AMENDMENT NO. 1 NOVEMBER 1984

IS : 4632-1968 SPECIFICATION FOR
SQUARE SLIDERS FOR STITCH REGULATORS FOR
SEWING MACHINES FOR HOUSEHOLD PURPOSES

TABLE 2 DIMENSIONS FOR SQAURE SLIDER FOR STITCH
REGULATORS, TYPE B

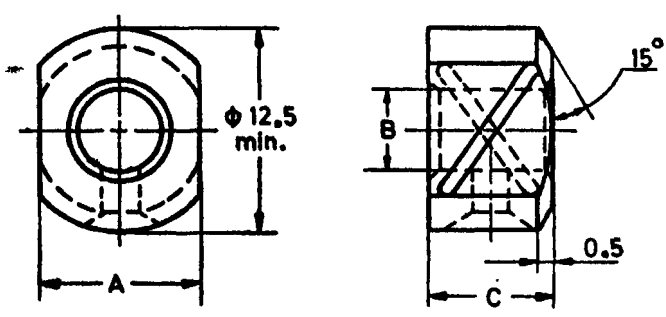
(Page 5, Table 2) — Substitute the following for the existing table:

A	B	C
Min	9.830	5.093	7.11
Max	9.848	5.105	7.24
